Office Action Summary	Application No. 10/823,165	Applicant(s) CHRISTIANSON, THOMAS R.	
	Examiner Jason M. Han	Art Unit 2875

DETAILED ACTION

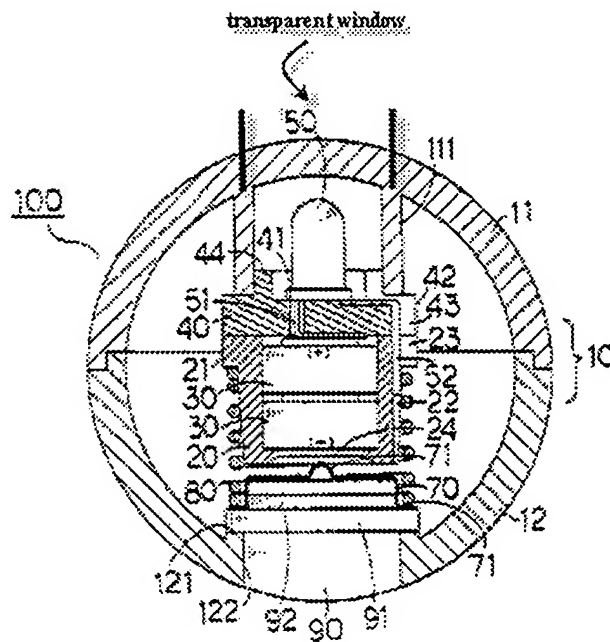
7. With regards to Claim 1, Hsu discloses a lamp including:

- A spherical body [Figure 1: (10)] having a front side containing a light portion [Figures 2-7: (11)] and a rear side [Figures 2-7: (12)] containing a pushbutton switch portion [Figures 2-7: (70-72, 90-92)];
- Whereby the outside of the spherical body includes a substantially entirely spherical surface [Figure 1];
- Said light portion [Figures 2-7: (11)] having a partially spherical surface that forms a continuous part of said spherical surface of said spherical body; and
- Said pushbutton switch portion [Figures 2-7: (90)] having a partially spherical surface that forms another continuous part of said spherical surface of said spherical body.

8. With regards to Claim 2, Hsu discloses the light portion having a transparent window [Figures 2-5: (111) and area adjacent; see drawing below] having said partially

spherical surface and at least one light-emitting element [Figures 2-5: (50)] inside said window.

11. With regard to Claims 4-5, Hsu discloses the claimed invention as cited above. In addition, Hsu teaches a transparent window [Figures 2-5: (111) and area adjacent; see drawing above] having said partially spherical surface and at least one light-emitting element [Figures 2-5: (50)] inside said window, as well as the pushbutton switch portion including a switch mechanism [Figures 3-4: (70)] inside/integral with a covering membrane [Figures 3-4: (90); Column 3, Lines 18-20], but does not specifically teach said covering membrane being flexible.
